Incorrect Emission Control Label – Install Revised Label – Canadian Vehicles Service Action S691

MODEL	1995 MY XJR
VIN	720001-754303

THIS SERVICE ACTION APPLIES TO CANADIAN VEHICLES ONLY.
REFER TO TECHNICAL BULLETIN 05.1-32 FOR U.S. VEHICLES.

LOCATION OF EMISSION CONTROL DATA LABEL

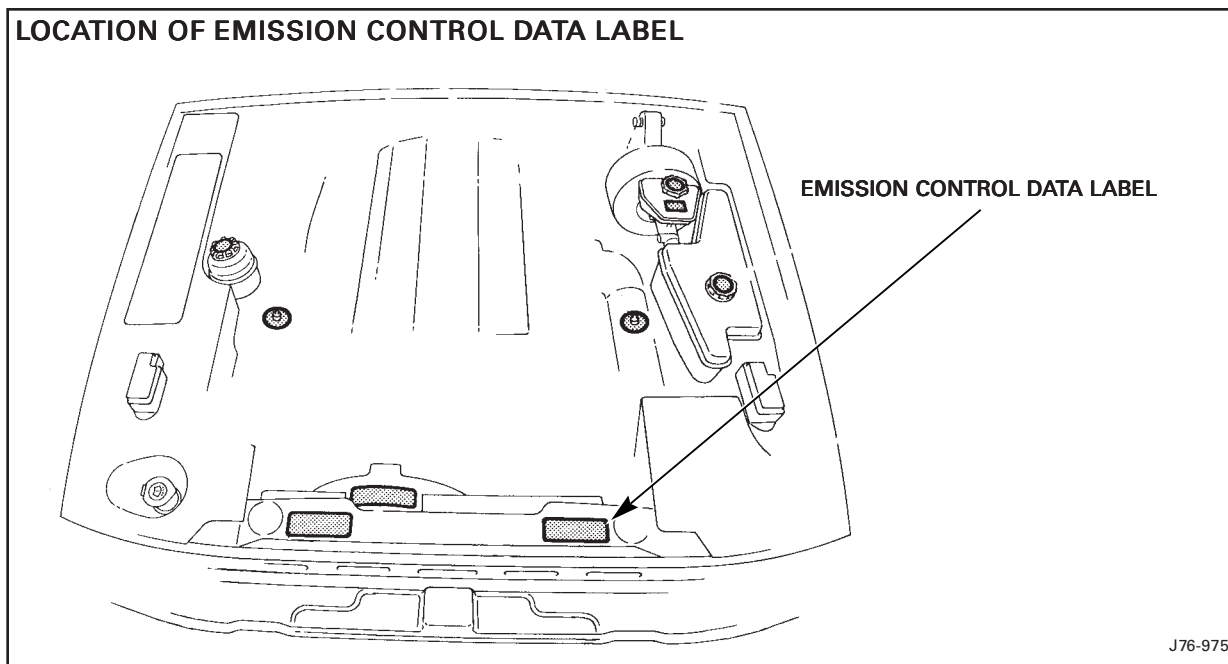
On all 1995 Model Year XJR Sedan Models within the above VIN range, the factory-installed Emission Control Data Label ("Tune-up Label") was incorrectly specified. This label is applied to the crossmember above the radiator, within the engine compartment. 1995 MY XJ6 4.0L Sedan models with naturally-aspirated AJ16 engines are NOT affected.

The existing label implies that the engine is equipped with an Exhaust Gas Recirculation system which is not the case.

2. Identify the Emission Control Data Label ("Tune-up Label"), located on the left side of the cross panel above the radiator (Illustration 2).
3. Clean off the existing label.
4. Apply the replacement label over the old label.
5. Apply an R691 authorized modification label to the Driver side B-pillar. (This label will immediately indicate to any other Dealer that the vehicle concerned has already been rectified).
